City of Fort Bragg

Meeting Agenda Planning Commission

Wednesday, April 30, 2025

PLANNING COMMISSION STAFF REPORT

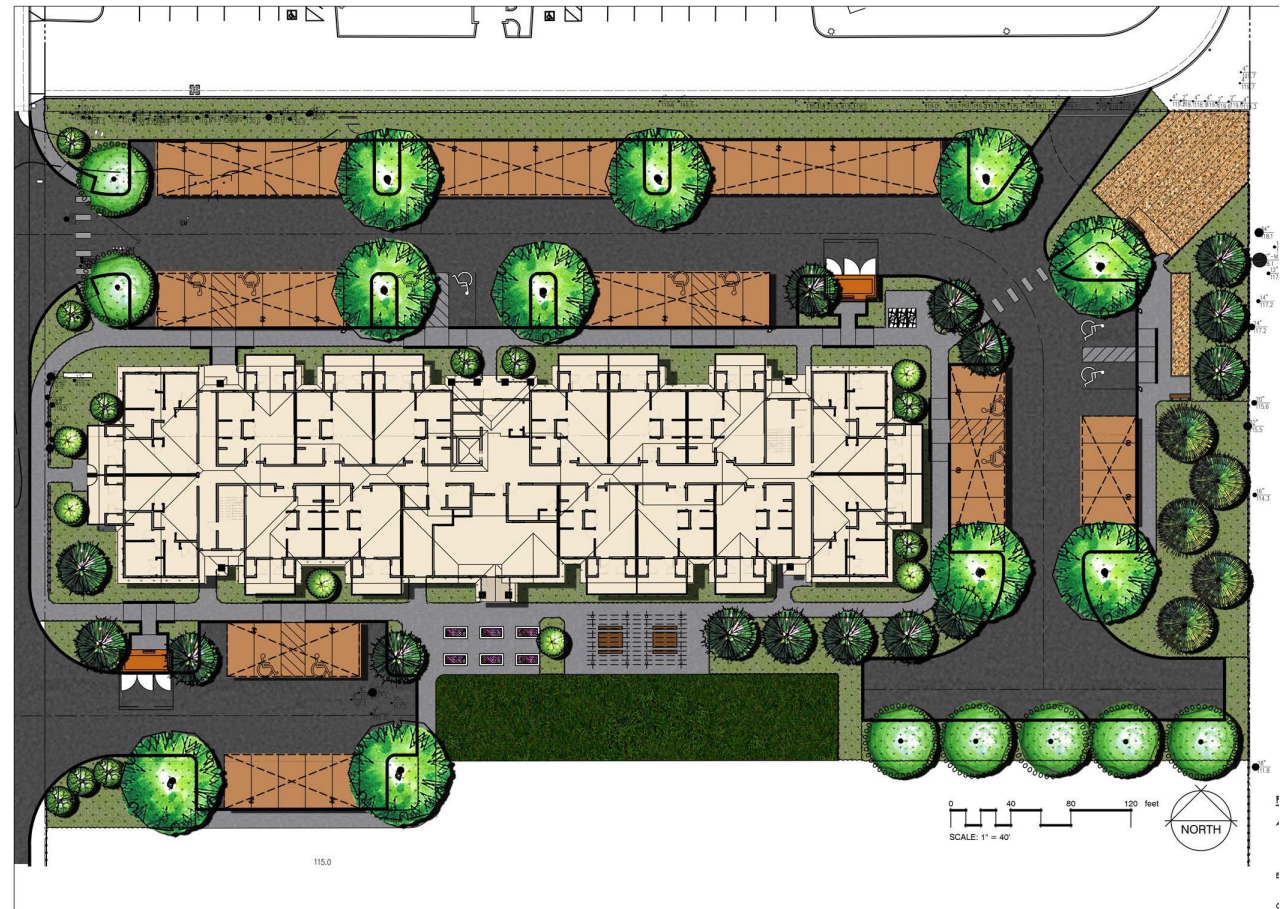
Special Conditions to remove trees bushes that hamper driver visibility, all landscaping must be non-native with native plants, retain existing trees as feasible, provide more landscaping at parking lot entrances, prohibit planting of invasive non-natives.
